**FINAL**  
**MITIGATION PLAN**

**FLETCHER MITIGATION SITE**

Re: NCIRT Review and USACE Approval of the Fletcher Site Draft Mitigation Plan; SAW-2016-02205; DMS Project #100004

SUBJECT: Fletcher Mitigation Site - NCIRT Comments during 30-day Mitigation Plan Review

Revision Sheet 0 9

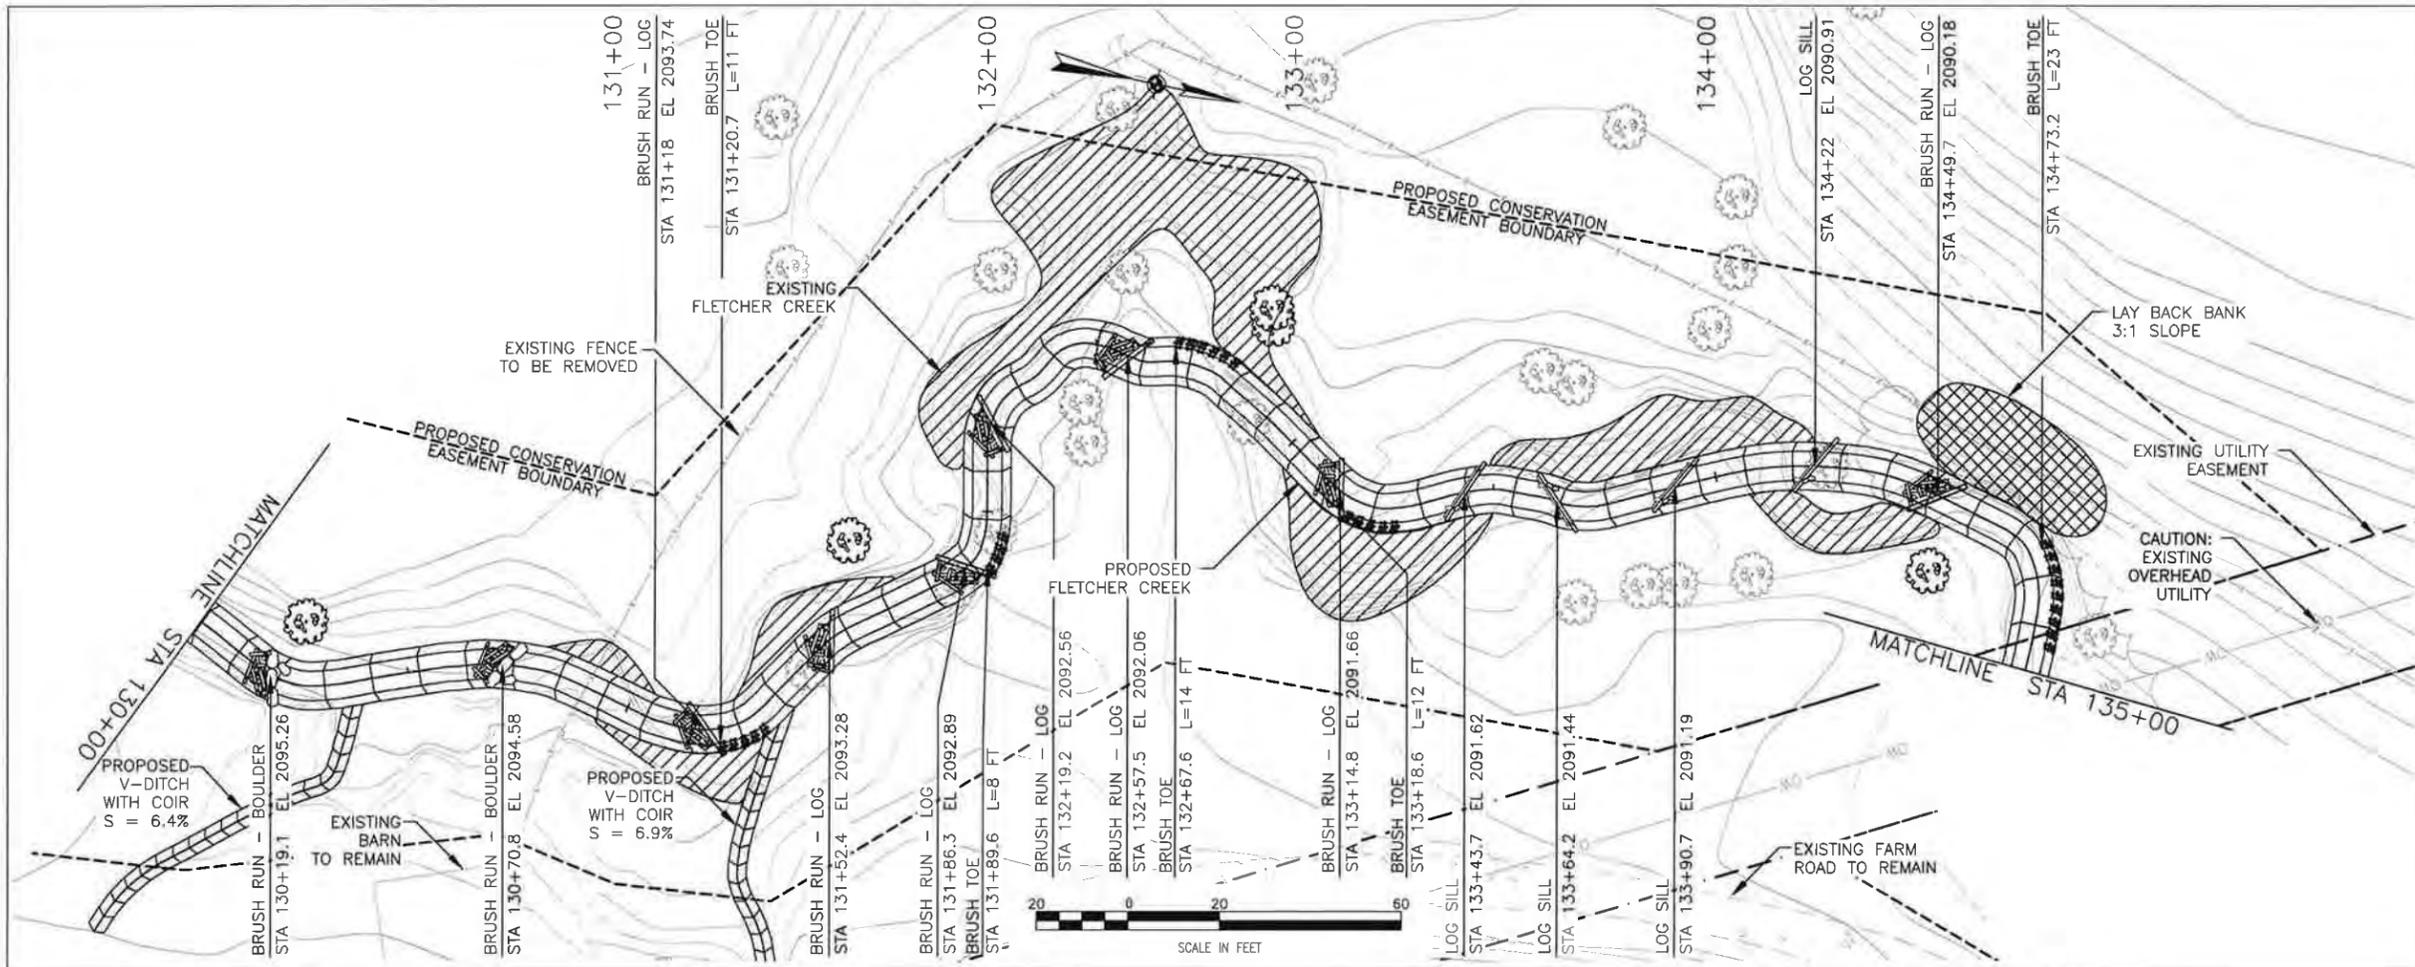
**Comment:** (10) On Design sheets 7-9, the Fletcher 1C channel bed is being brought up 3-4 feet for about 1,100 linear feet. Please note that these areas must maintain flow to garner stream credit.

**Response:** Final design plans include a note on Detail Sheet 3D indicating soil fill used below the proposed bed shall have a minimum clay content or where sufficient clay material is not available clay plugs shall be used to restrict loss of base flow.

Sheet: 12

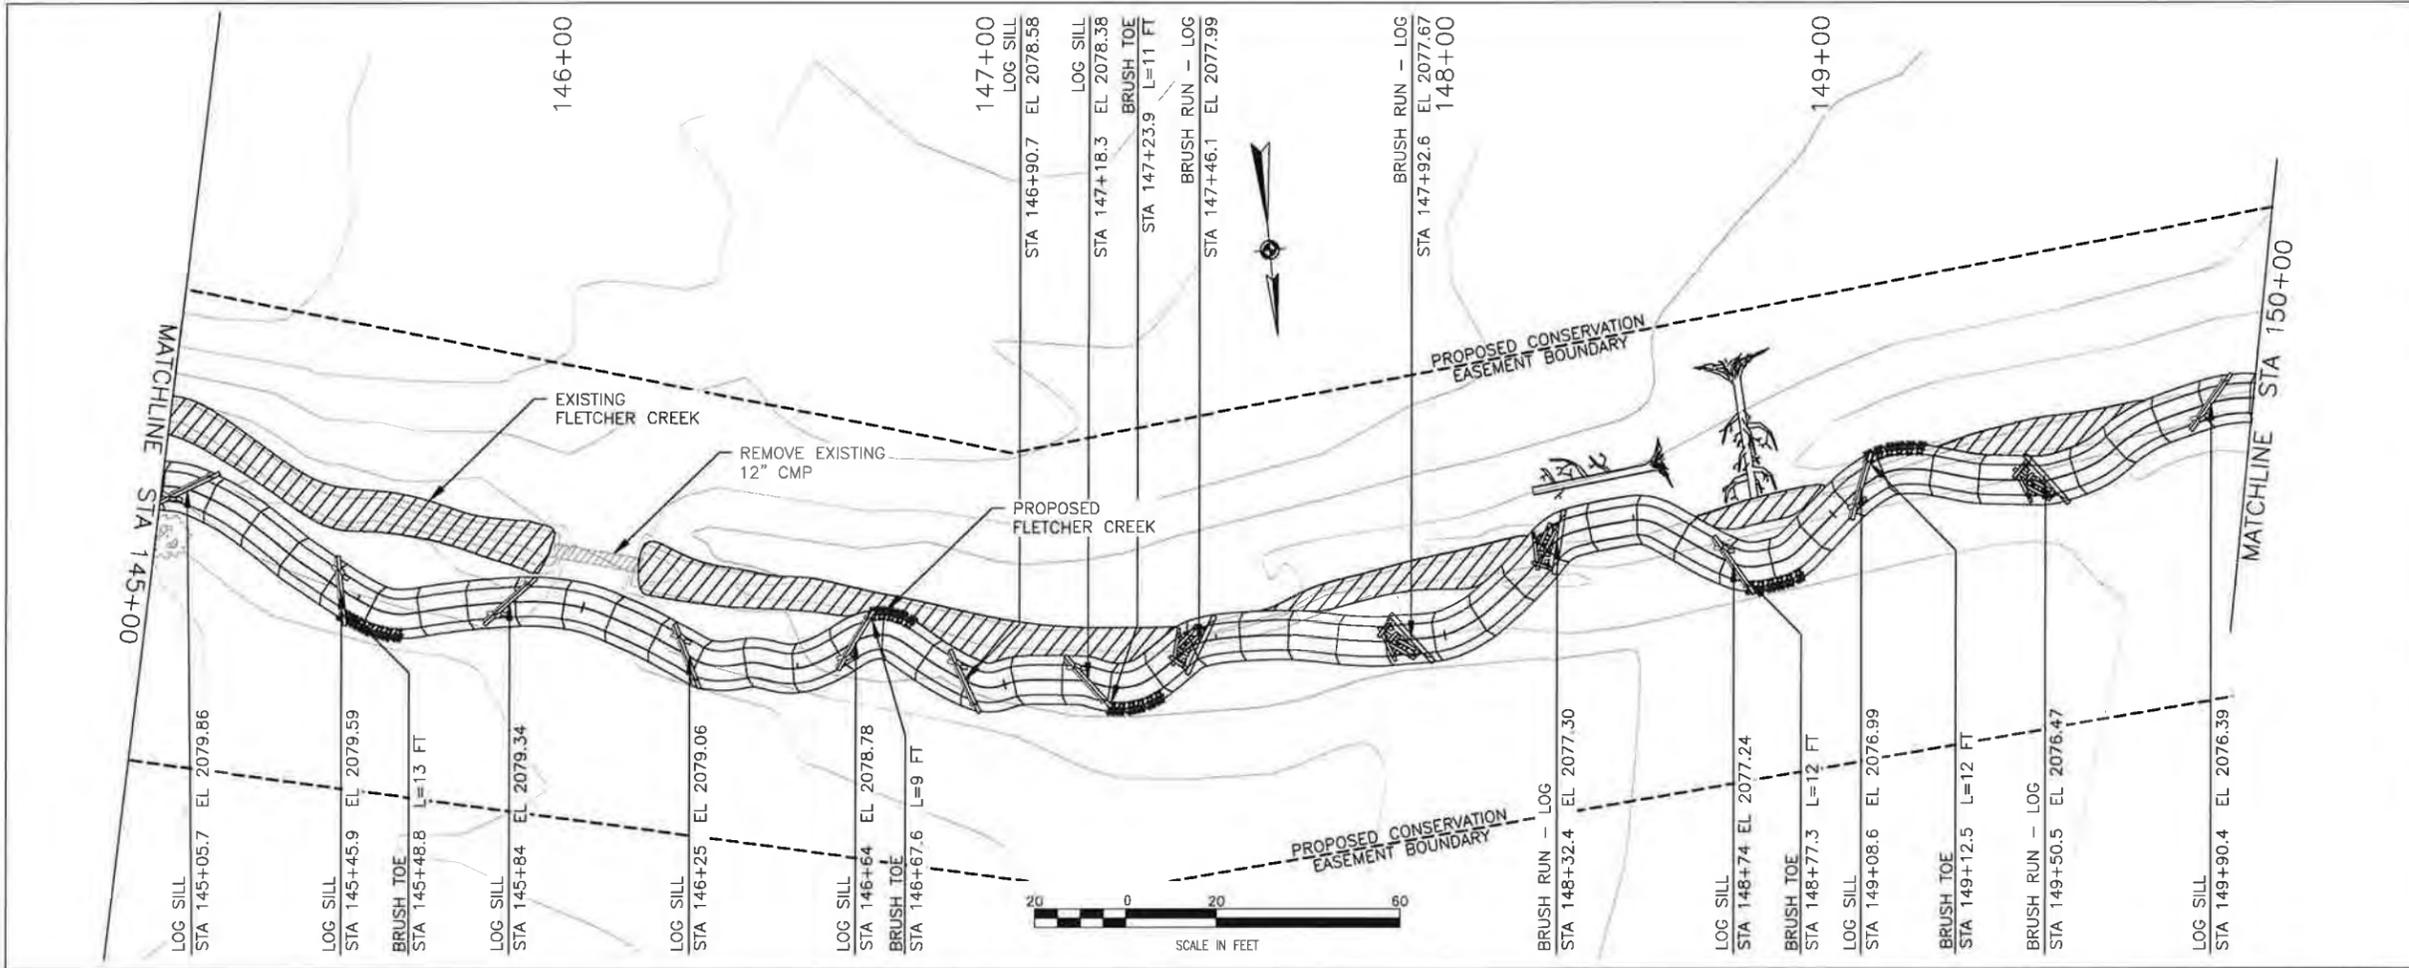
**Comment:** (11) Some of the crossings, as shown on Design sheet 12 have rip rap outlet protection pads. Please realize that the stream footage for these areas are not allowed for stream credit.

**Response:** Stream credit quantities have been re-checked to make sure areas of riprap outlet protection are not included.
